DfT Reference: TWA/24/APP/03
Document Ref: CD26-01-APP-W9-3
The Cambourne to Cambridge Order

APPENDICES TO PROOF OF EVIDENCE
of
Jack Southon
of WSP

CAMBOURNE TO CAMBRIDGE (BIN BROOK HYDRAULIC MODEL REVIEW)

Figure 15 - Roughness Values for culverts

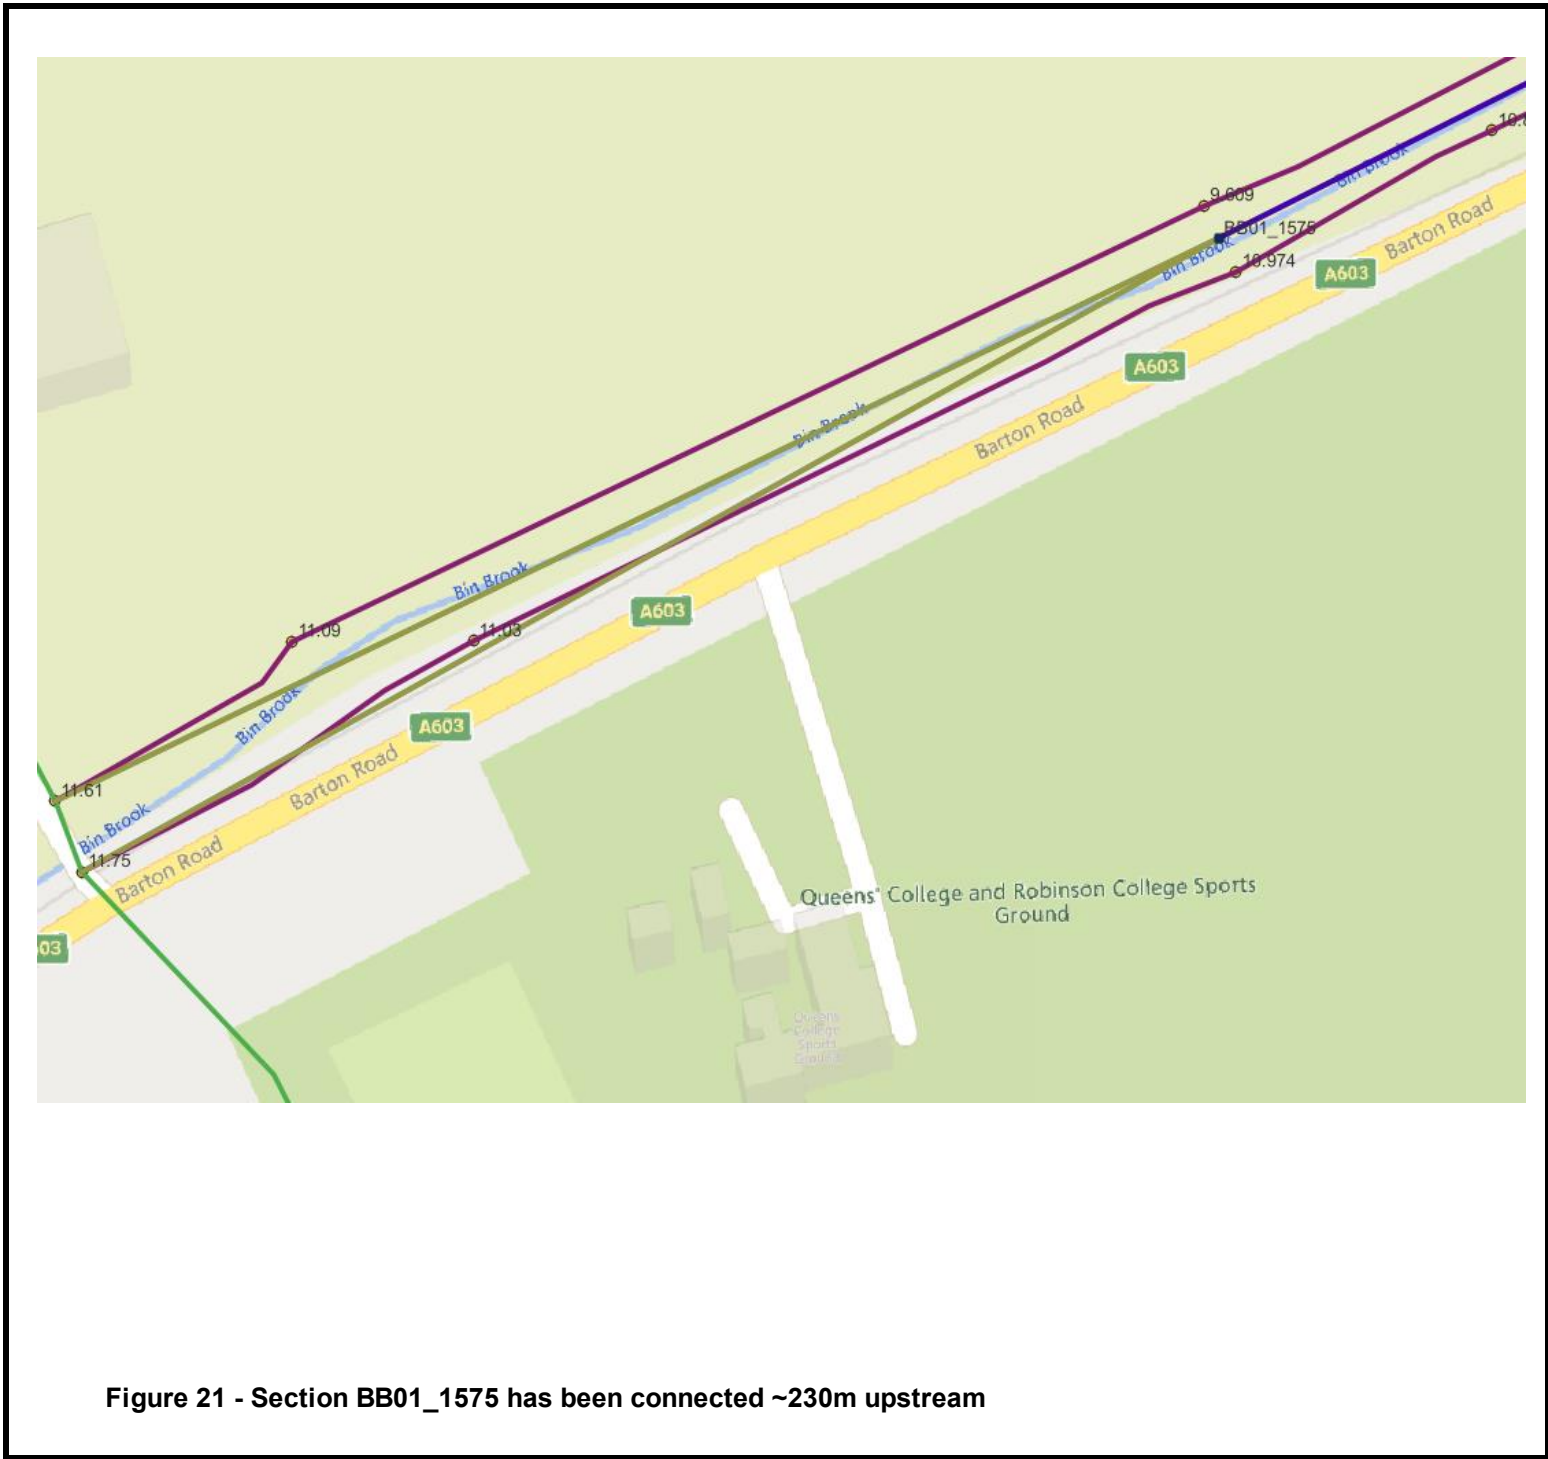
Figure 16- Glass walling in 2d

7.1	Number of domains?	OK	One 2D domain.						
7.2	Area of 2d domain/s	Red	55 hectares. There is glass walling occurring in the 1,000-year +19% CC results near Clare Hall Gym and Pool in both the Baseline and Proposed modelling.	The code layer needs to be extended to prevent glass walling.	Code layer extended upstream.	Red	There is still some glass walling - please see Figure 16.

Figure 1: Downstream boundary not snapped to code layer

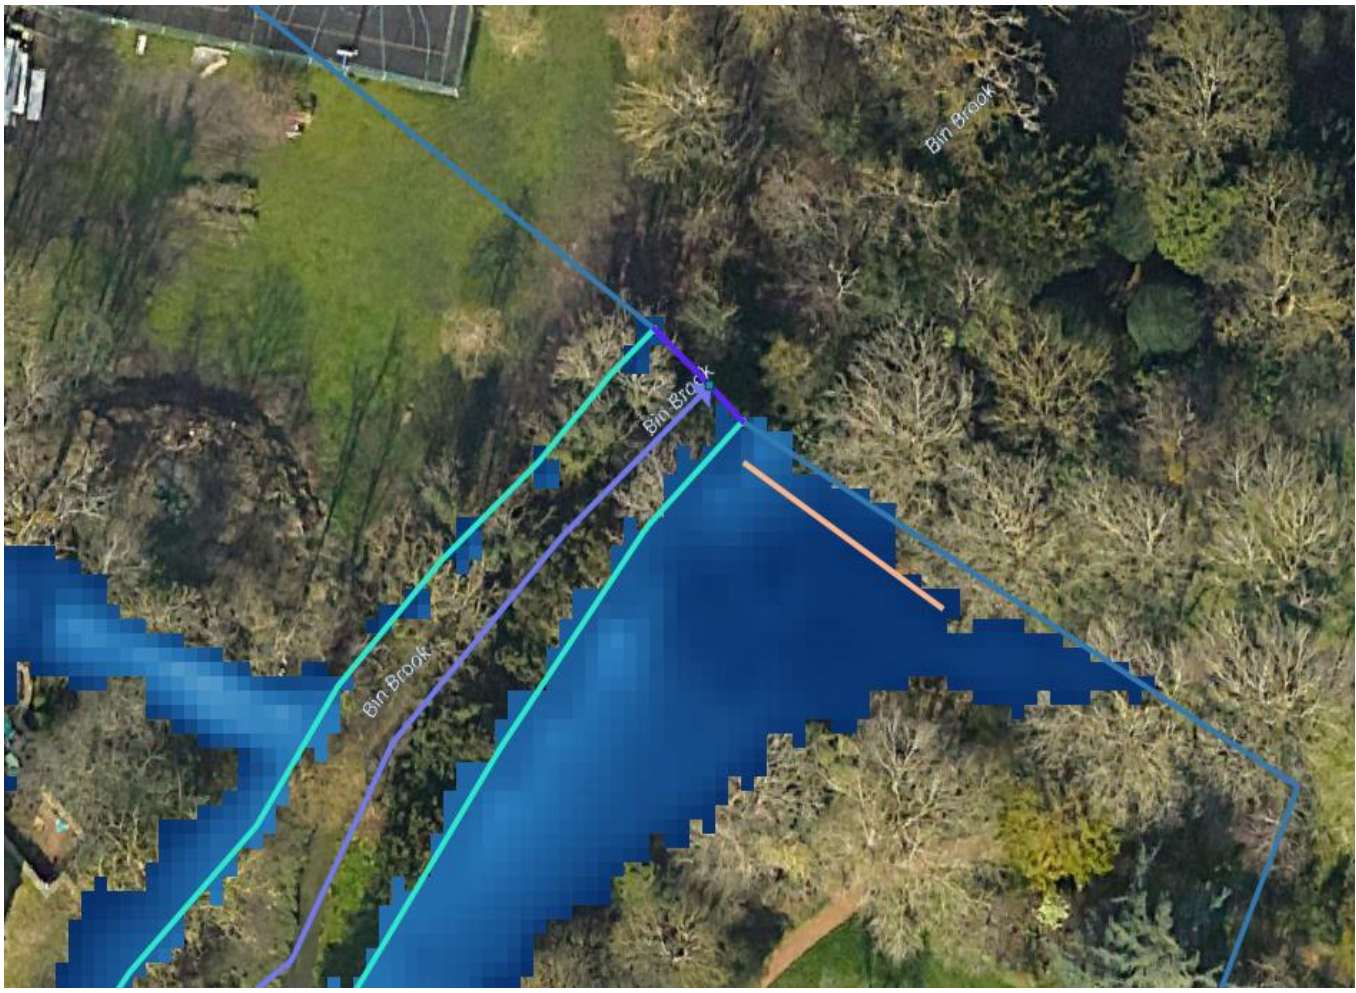
9.2	Is the model boundary suitably large? i.e. the flood extent should not reach the boundary.	Red	There is glass walling at the downstream extent of the model as the downstream boundary is not snapped to the 2d_code layer, and also does not extend far enough east, see Figure 1 in the 'Figures' tab. There is also glass walling in all three events at the upstream boundary, see Figure 5 in 'Figures' tab. No other glass walling.	Extend the downstream boundary eastwards to cover the full extent of the flooding. Justify the presence of glass walling at the upstream extent of the model.	The downstream boundary has been updated to snap to the code layer. Extended upstream extent of the model to prevent glass walling.	Red	There is still some glass walling - please see Figure 16.	See 7.2

Figure 3: HX link gaps at watercourses and structures need closing

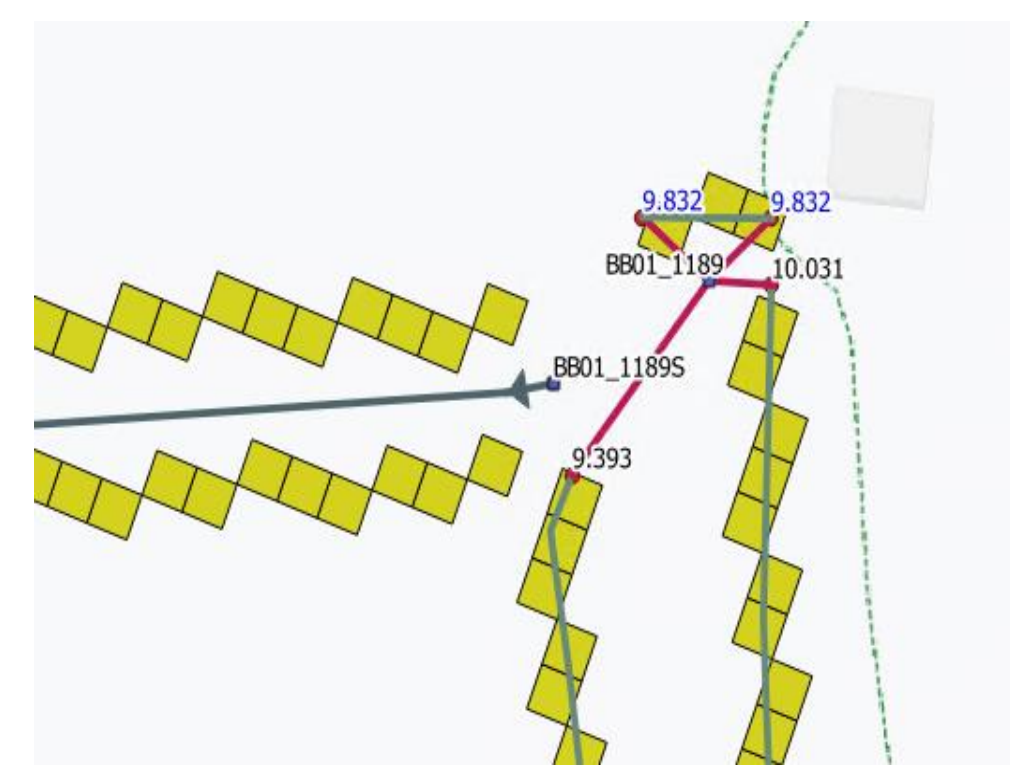
12.1	How have the 1D/2D models been coupled, is it appropriate?	Red	The 1D and 2D domains have been linked using HX and CN lines. Connections have mostly been digitised appropriately. The upstream of the model should be snapped to the code boundary (see Figure 2 in the 'Figure' tab). The HX lines at the structures throughout the model and the link to the ditch need to be reviewed, many should be closed so a single HX line is applied (see Figure 3 in the 'Figures' tab as an example).	Please amend throughout the model.	Gaps in the 1D and 2D domains have been closed.	OK	The code boundary is snapped with the upstream boundary. The gaps have been closed

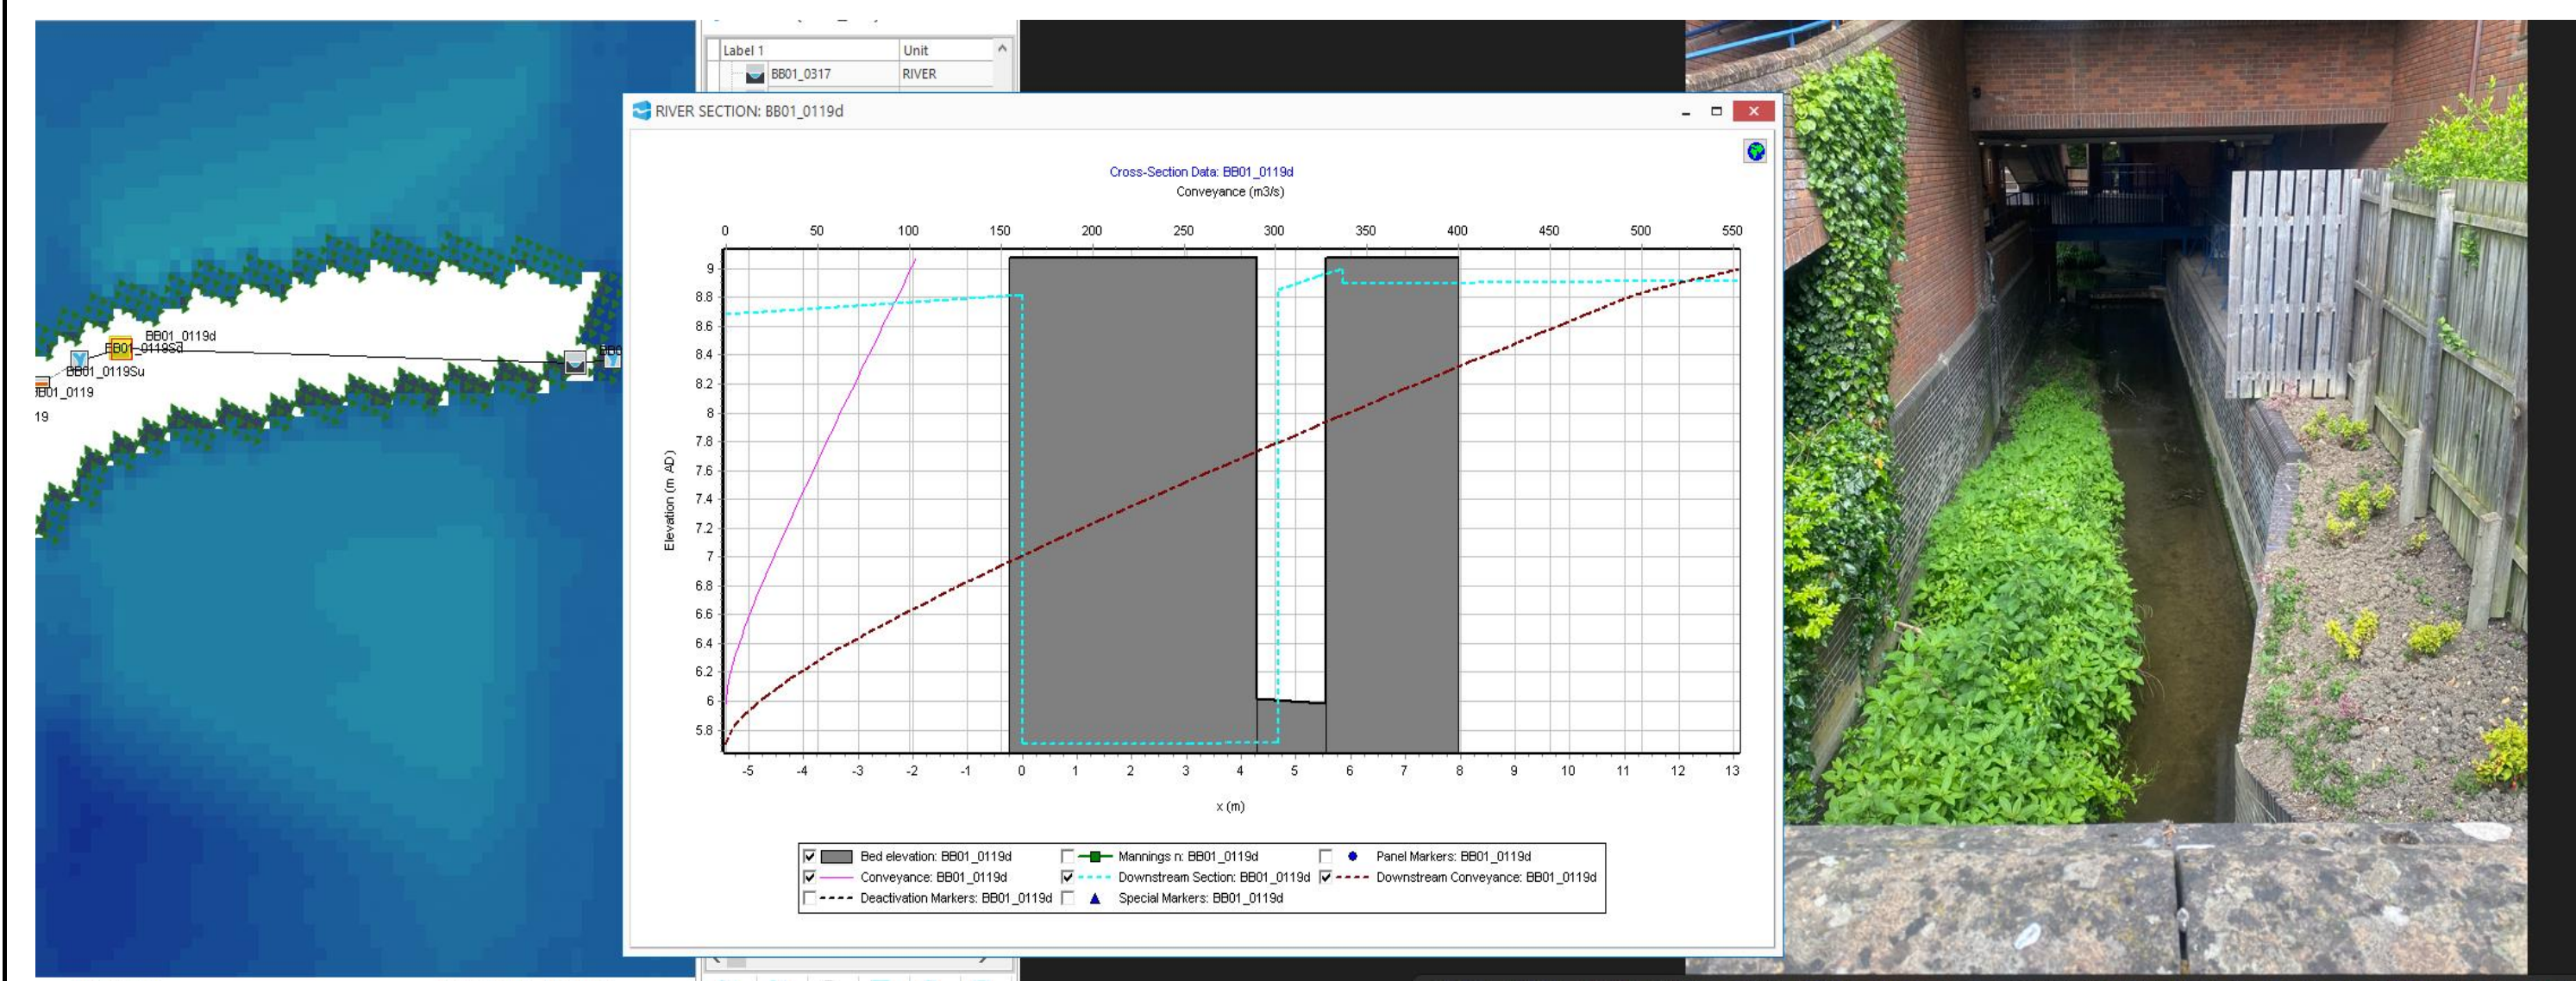
Figure 9: Section BB01_0119d is located downstream of the weir BB01_0119. The distance to next is 70m to the bridge. The channel cross section is 1.7m wide upstream and 4.7m downstream - this is modelling a tapering channel, the survey photo suggests the channel widens immediately downstream of the weir - the modelled channel reach appears to be too narrow as interpolates from one section to the next.

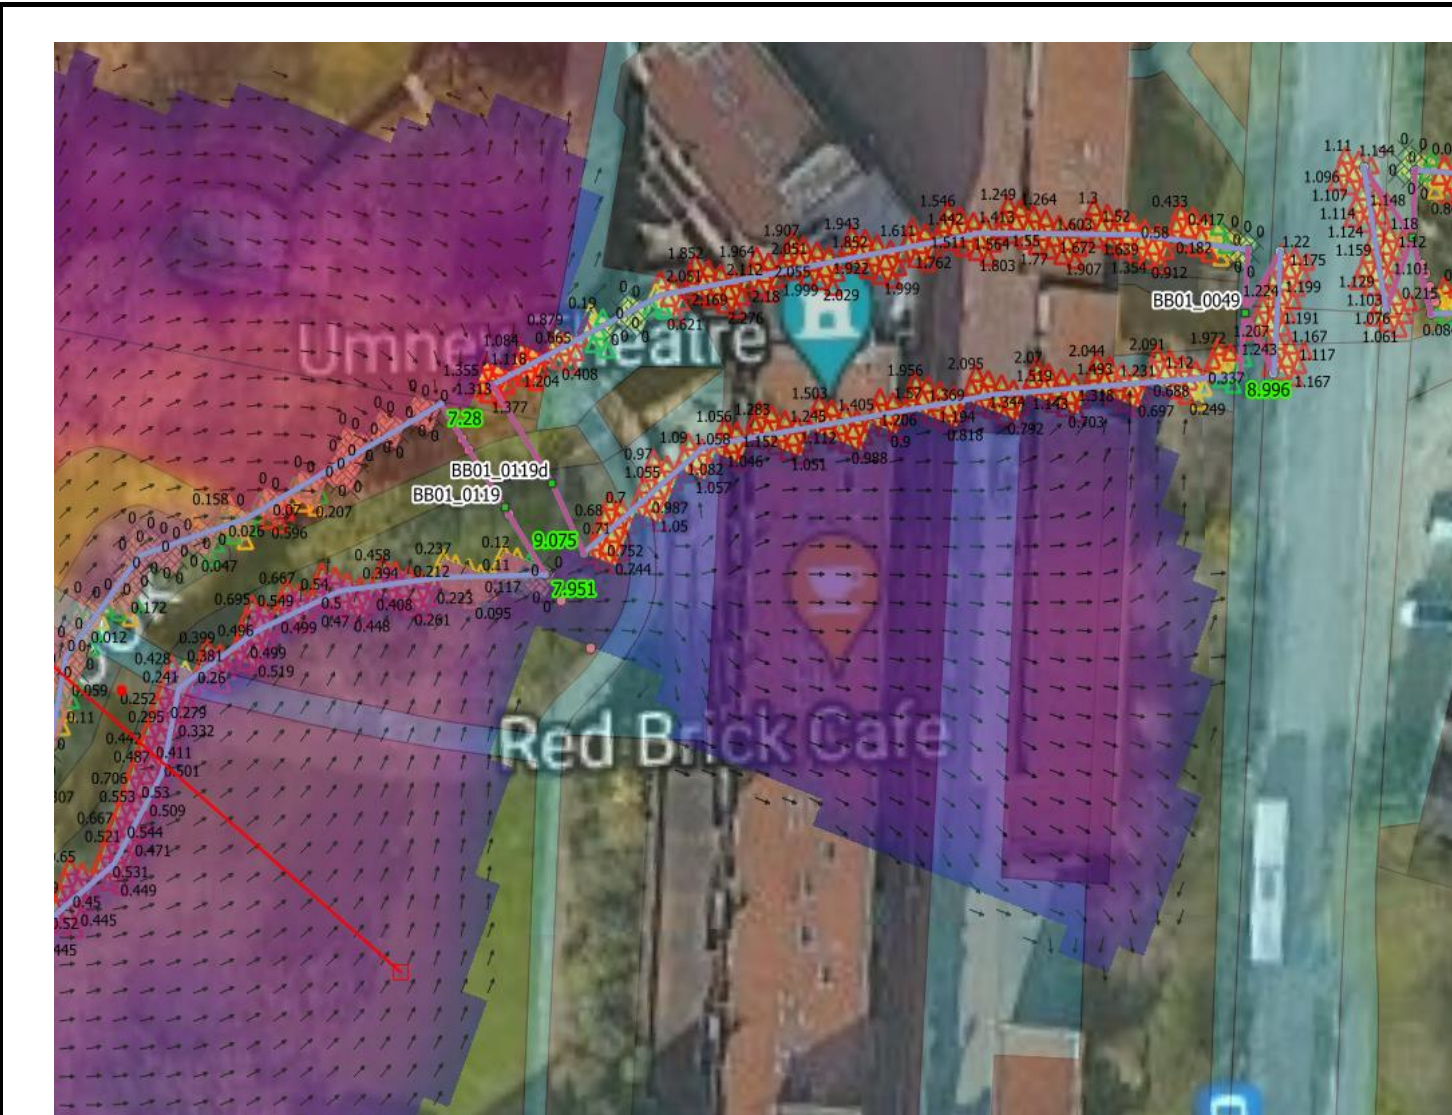
Figure 11: Split in the 2D link location for the weir looks slightly too far upstream. Flow appears to be by-passing the weir but the survey photos indicate ground levels behind may be higher. Modelling a manning's 'n' is standard however in this instance further consideration needs to be given on the levels and flow mechanisms being modelled under / through the building. Are these correct, can water flow through the building and back into channel?
